Planning Commission Vote Report

Petition: P.Z. 12-2016 Chesterfield Commerce Center (150 N. Eatherton Rd.): A

Change In Zoning Responses to "List of Items" discussed at 11/14/16 Public Hearing

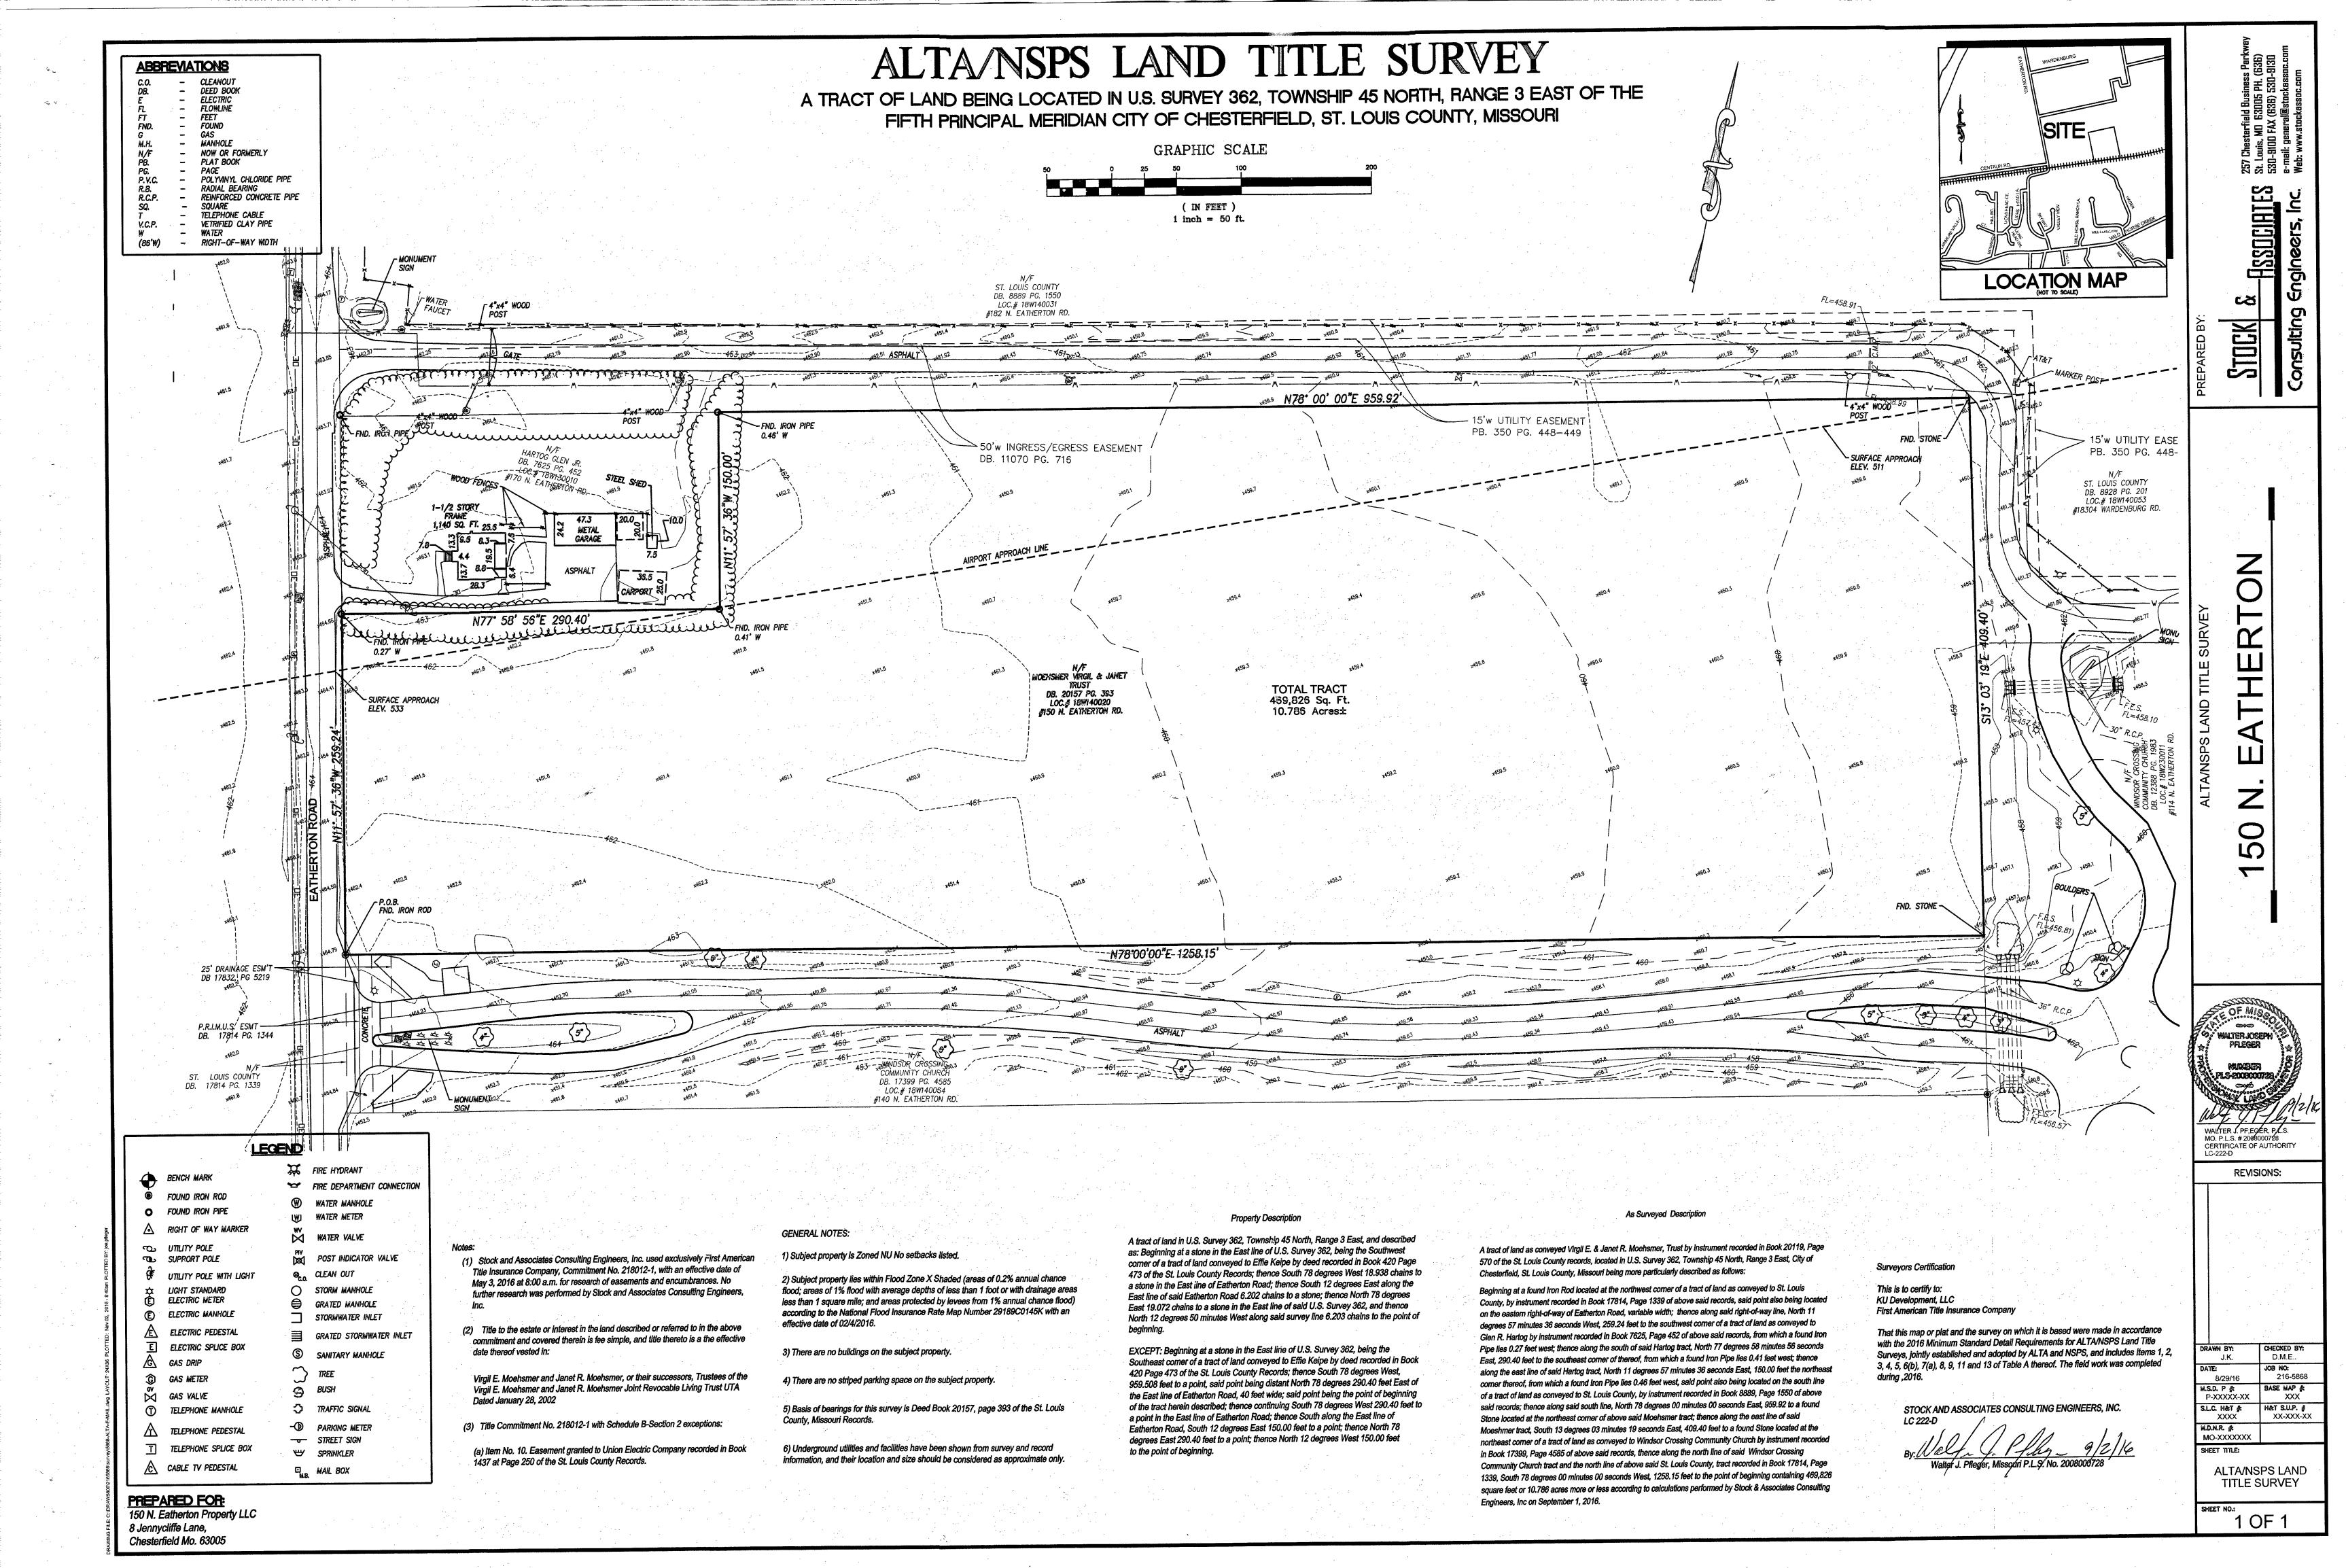
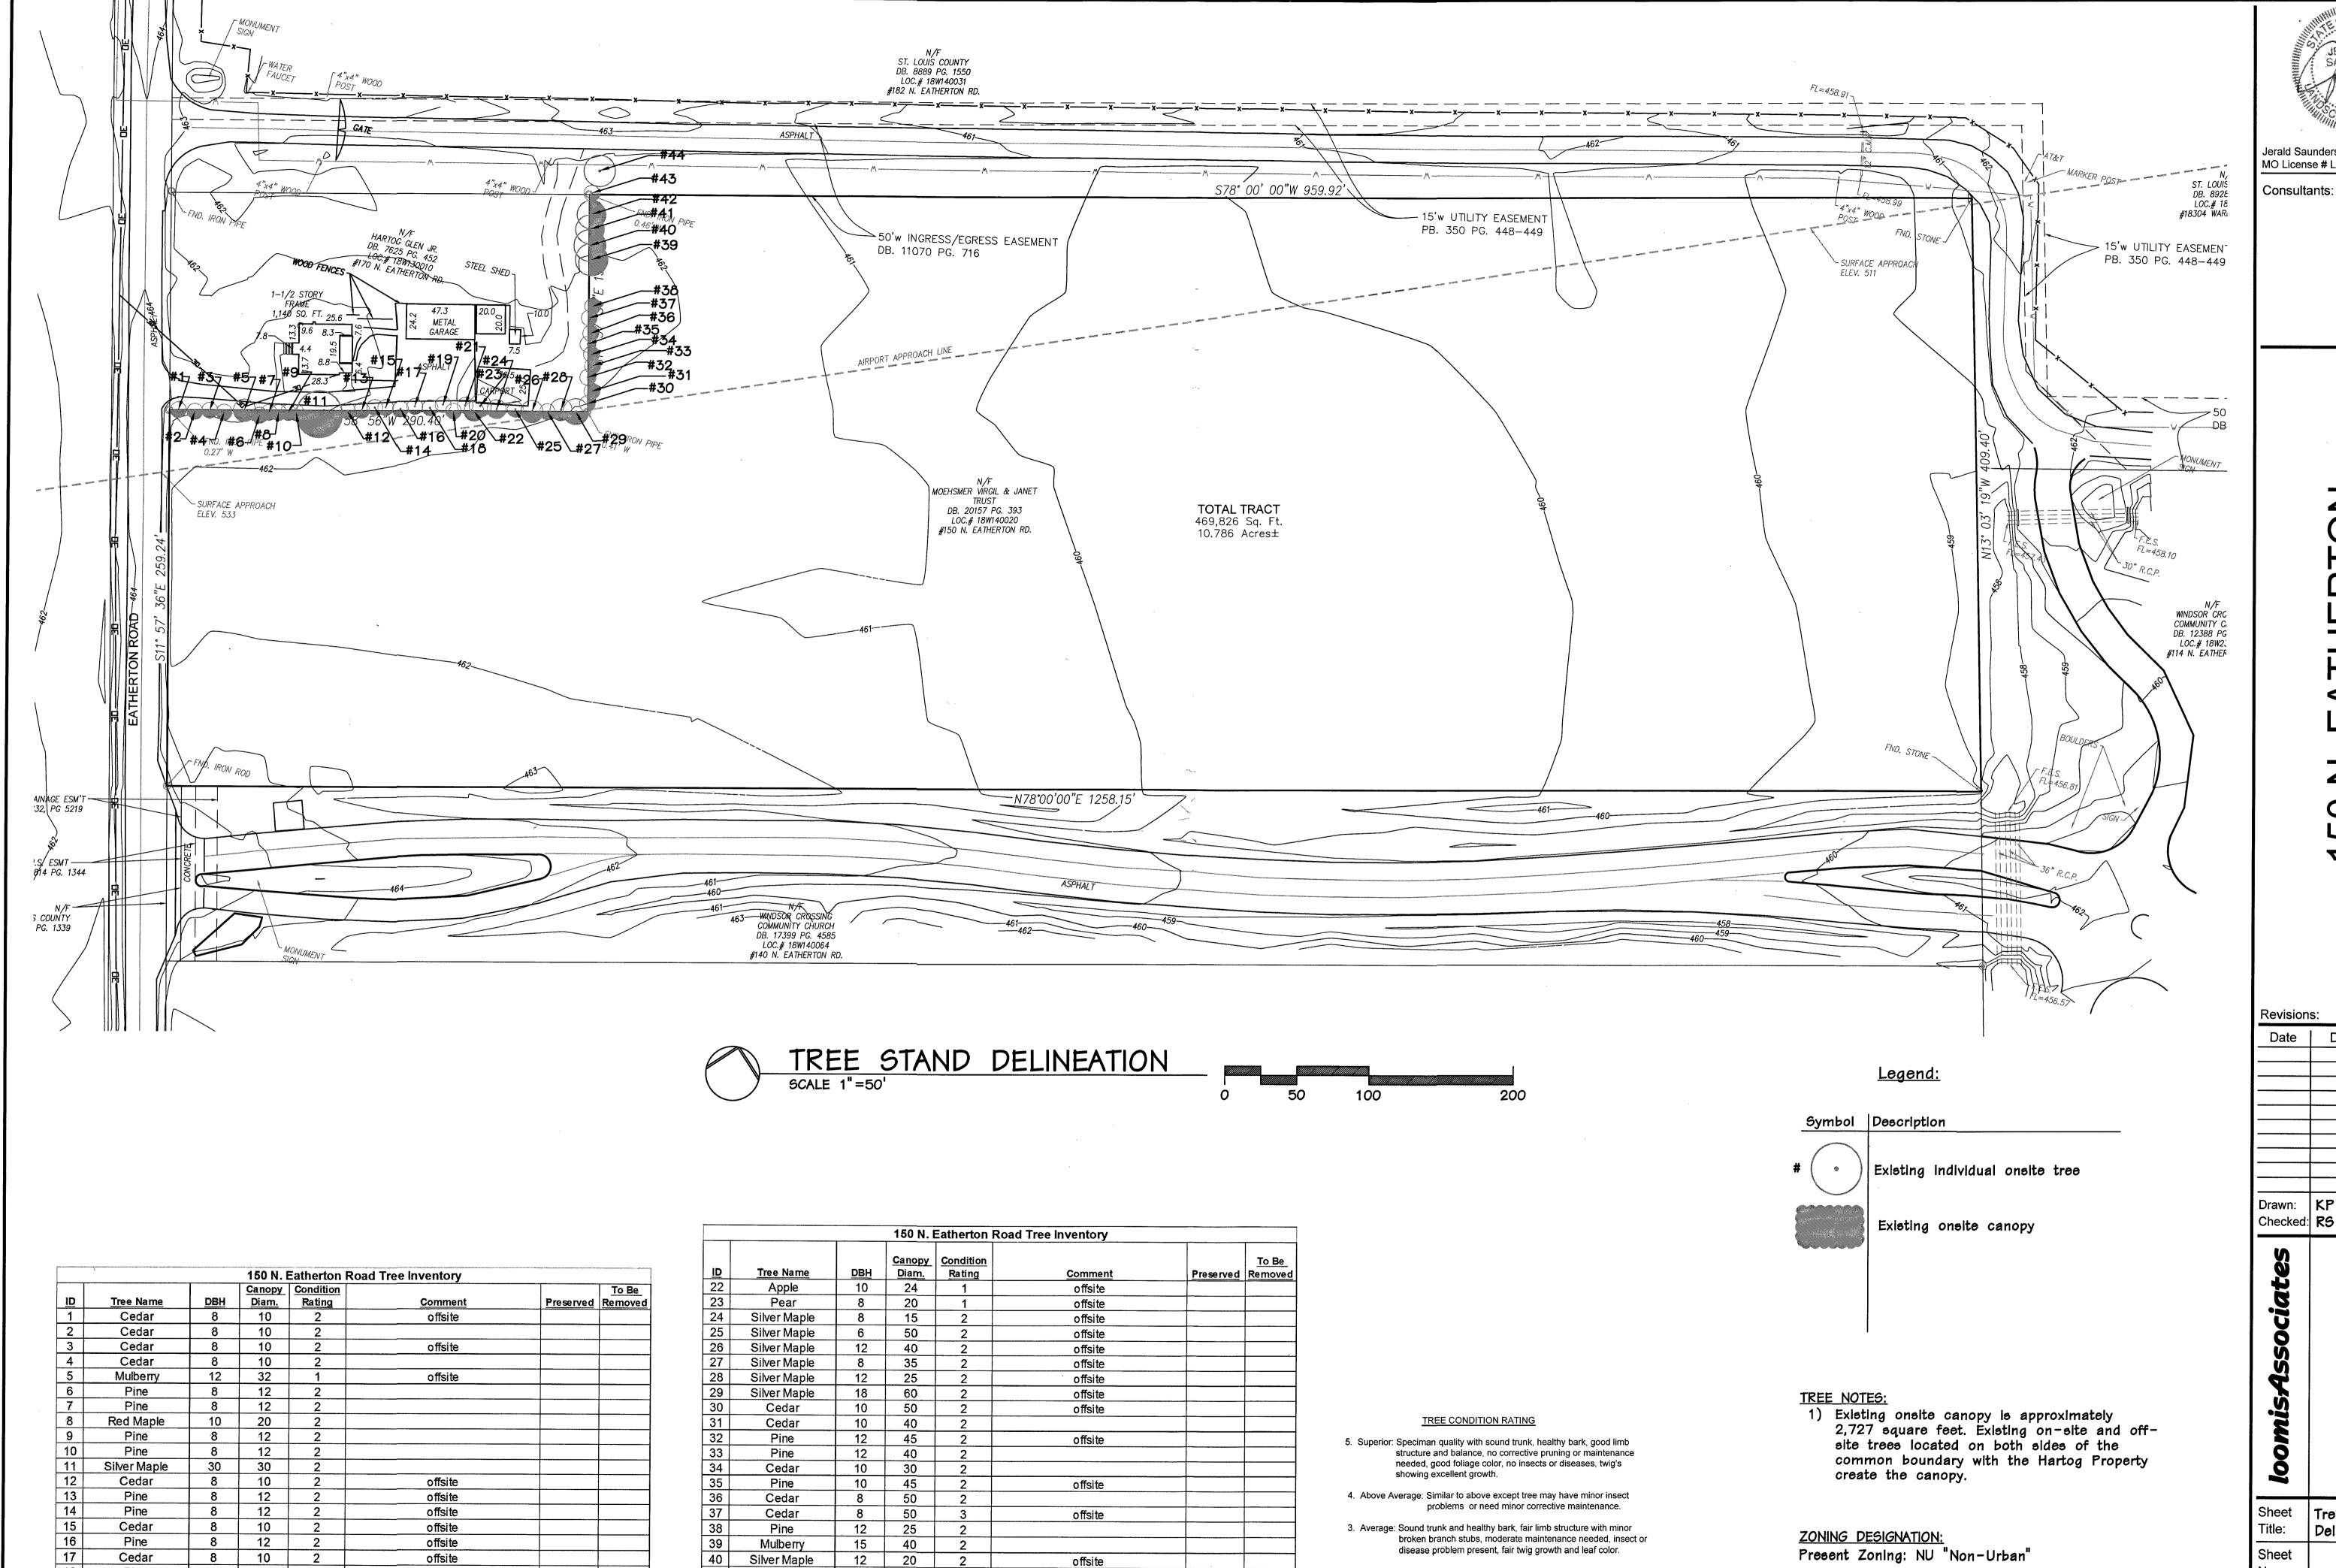
• The benchmark shown on the preliminary plans is not current.

• It appears that the proposed grading may block some culverts draining under the private road from the airport.

• The Chesterfield Valley Master Storm Water elevation for this site is 463.36. The finished floor elevation appears to be three feet higher than this elevation.

• The preliminary plan shows stormwater draining in a pattern that does not follow the Chesterfield Valley Master Stormwater Plan. In addition, pipes will be required under the entrance driveway which are not currently modeled in the plan.

Response: We have updated the benchmark on the plan.

Response: We have provided more detail to demonstrate proposed grading does not block culvert drainage.

Response: A note has been added to the plan that the "Chesterfield Valley Master Stormwater Elevation for this site is 463.36".

Response: As discussed in our meeting, we reviewed the previously approved Drainage Plan for this property owner to the existing drainage channel on The Crossing Property.

We have added three (3) - 36° diameter culverts under the proposed driveway at Eatherton Road to the Preliminary Plan.
